WILLIAMSON COUNTY, TEXAS CHANGE ORDER NUMBER: 1

Davind	Doole			
1. CONTRACTOR: Champion Site Prep	ROCK		Project:	1805-229
2. Change Order Work Limits: Sta. 10+00 to	Sta.	34+48	Roadway:	Bagdad Road at CR 278

Bagdad Road at CR 278 Williamson County Project No. 1805-229

Change Order No. 1

SHEET L8 OF L29

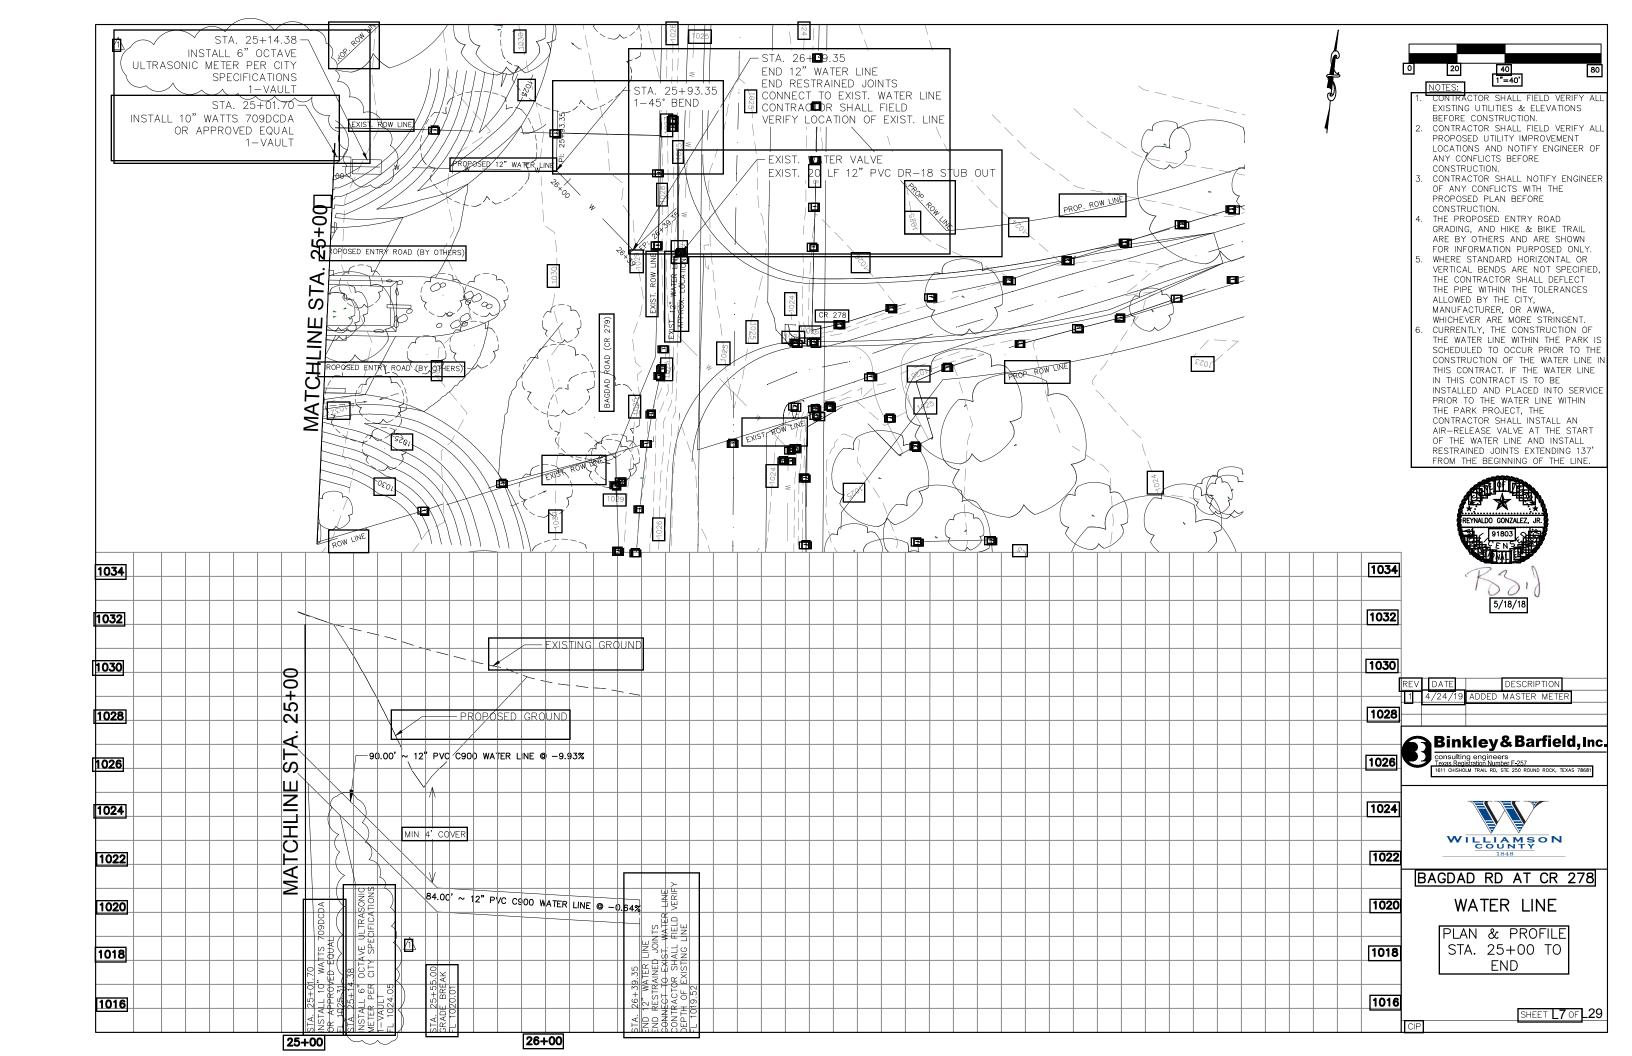
<u>Water Line</u>: This Change Order adds a service meter and replaces DR-18 pipe with DR-14 pipe for the 12" waterline inside the park as required by the Engineer. This Change Order compensates the Contractor for additional work and material, in order to connect the 12" waterline to the waterline installed by others at the west end of the park road. This Change Order adds an irrigation stub-out on the 12" waterline and 4" PVC sleeves under the roadway for future irrigation needs inside the park.

55		6" Meter Ass	embly			
DATE: TO: ATTN:	08/14/19 HNTB Feng Chen		JOB NA ESTIMA LOCATI	ATOR:	CR 279 BT Liberty Hill	
	DESCRIPTION	QTY	UNIT	RATE		
1.	6" Meter Assembly	1	LS	\$29,400.00		\$29,400.00
				Total:		\$29,400.00
2.	OH/P	10	96	\$2,940.00		\$2,940.00
NOTE:	Pricing above includes price 6" met meter. Anything not listed above is *Price valid for 30 days		Price does	not include		
				TOTAL CREDE	23	
				TOTAL CREDIT	13	\$32,340.00
АССЕРТАЛ	NCE OF PROPOSAL- The above prices,	specifications and cond	litions are s

I		R	EΥ	DATE		DESCRIF	PTION
I		7	1	4/24/19	ADDED	MASTER	METER
I							
н	I 7

ED(4) - 14

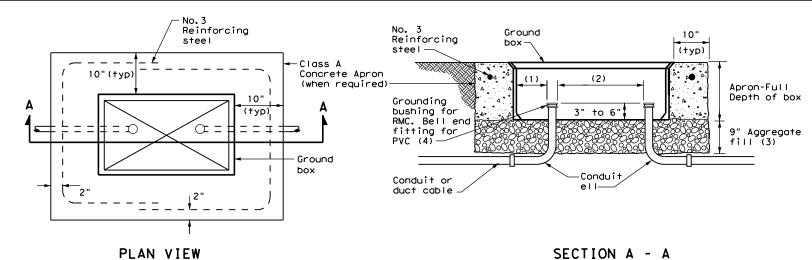
PROJECT: Bagdad at CR 278/Park Road Wilco No. 1805-229 DATE: 3/11/19 TO: HNTB: Fabian Kalapach, PE REFERENCE: ITS ground boxes for multi duct conduit PROBLEM: Question Type D ground boxes are a third the cost of the ITS ground boxes originally specified. More boxes may be needed because the distance between boxes should be 300 - 350 ft for wire pulls instead of the 800 feet called for in the plans. Is it acceptable to use the Type D ground boxes along the Park Road and on the remaining portions of the project? RECOMMENDED SOLUTION: Use the smaller Type D ground boxes along the Park Road and on the remaining portions of the project.	REQUEST FOR INFORMATION FORM				
REFERENCE: ITS ground boxes for multi duct conduit PROBLEM: Question Type D ground boxes are a third the cost of the ITS ground boxes originally specified. More boxes may be needed because the distance between boxes should be 300 - 350 ft for wire pulls instead of the 800 feet called for in the plans. Is it acceptable to use the Type D ground boxes along the Park Road and on the remaining portions of the project? RECOMMENDED SOLUTION: Use the smaller Type D ground boxes along the Park Road and on the remaining portions of the project. Clayton Weber, HNTB, Construction Manager Originator Christen Eschberger, PE, HNTB Supervisor RESPONSE: The Type D ground boxes can be used as an alternative to the large concrete ground boxes called out in the plans for the ITS layout. See the attached details ED(4)-14. Fabian Kalapach, PE 2/6/2019	RFI NO.: PROJECT:	Bagdad at CR 278/Park Road	RESPON	SE REQUESTED BY

PROBLEM: Question Type D ground boxes are a third the cost of the ITS ground boxes originally specified. More boxes may be needed because the distance between boxes should be 300 - 350 ft for wire pulls instead of the 800 feet called for in the plans. Is it acceptable to use the Type D ground boxes along the Park Road and on the remaining portions of the project? RECOMMENDED SOLUTION: Use the smaller Type D ground boxes along the Park Road and on the remaining portions of the project. Clayton Weber, HNTB, Construction Manager Originator Christen Eschberger, PE, HNTB Supervisor RESPONSE: The Type D ground boxes can be used as an alternative to the large concrete ground boxes called out in the plans for the ITS layout. See the attached details ED(4)-14. Fabian Kalapach, PE 2/6/2019	то:	HNTB: Fabian Kalapach, PE			
Type D ground boxes are a third the cost of the ITS ground boxes originally specified. More boxes may be needed because the distance between boxes should be 300 - 350 ft for wire pulls instead of the 800 feet called for in the plans. Is it acceptable to use the Type D ground boxes along the Park Road and on the remaining portions of the project? RECOMMENDED SOLUTION: Use the smaller Type D ground boxes along the Park Road and on the remaining portions of the project. Clayton Weber, HNTB, Construction Manager Originator Supervisor Christen Eschberger, PE, HNTB Supervisor RESPONSE: The Type D ground boxes can be used as an alternative to the large concrete ground boxes called out in the plans for the ITS layout. See the attached details ED(4)-14. Fabian Kalapach, PE 2/6/2019	REFERENCE:	ITS ground boxes for multi duct conduit

needed because the distance between boxes should be 300 - 350 ft for wire pulls instead of the 800 feet called for in the plans. Is it acceptable to use the Type D ground boxes along the Park Road and on the remaining portions of the project? RECOMMENDED SOLUTION: Use the smaller Type D ground boxes along the Park Road and on the remaining portions of the project. Clayton Weber, HNTB, Construction Manager Originator Christen Eschberger, PE, HNTB Supervisor RESPONSE: The Type D ground boxes can be used as an alternative to the large concrete ground boxes called out in the plans for the ITS layout. See the attached details ED(4)-14. Fabian Kalapach, PE 2/6/2019	PROBLEM: Q	uestion			
Use the smaller Type D ground boxes along the Park Road and on the remaining portions of the project. Clayton Weber, HNTB, Construction Manager Christen Eschberger, PE, HNTB Supervisor	needed becaus	e the distance between boxes should be 30	0 - 350 ft for w	vire pulls instead of the	800 feet called for

Clayton Weber, HNTB, Construction Manager Originator RESPONSE: The Type D ground boxes can be used as an alternative to the large concrete ground boxes called out in the plans for the ITS layout. See the attached details ED(4)-14. Fabian Kalapach, PE 2/6/2019	RECOMMEND	ED SOLUTION:			
Manager Originator Supervisor RESPONSE: The Type D ground boxes can be used as an alternative to the large concrete ground boxes called out in the plans for the ITS layout. See the attached details ED(4)-14. Fabian Kalapach, PE 2/6/2019	Use the smalle	,, ,	and on the re	emaining portions or the	project.

RESPONSE: The Type D ground boxes can be used as an alternative to the large concrete ground boxes called out in the plans for the ITS layout. See the attached details ED(4)-14. Fabian Kalapach, PE 2/6/2019			Christen I	Eschberger, PE, HNTB	
The Type D ground boxes can be used as an alternative to the large concrete ground boxes called out in the plans for the ITS layout. See the attached details ED(4)-14. Fabian Kalapach, PE 2/6/2019					•
The Type D ground boxes can be used as an alternative to the large concrete ground boxes called out in the plans for the ITS layout. See the attached details ED(4)-14. Fabian Kalapach, PE 2/6/2019					
	, ,			crete ground boxes call	ed out in the
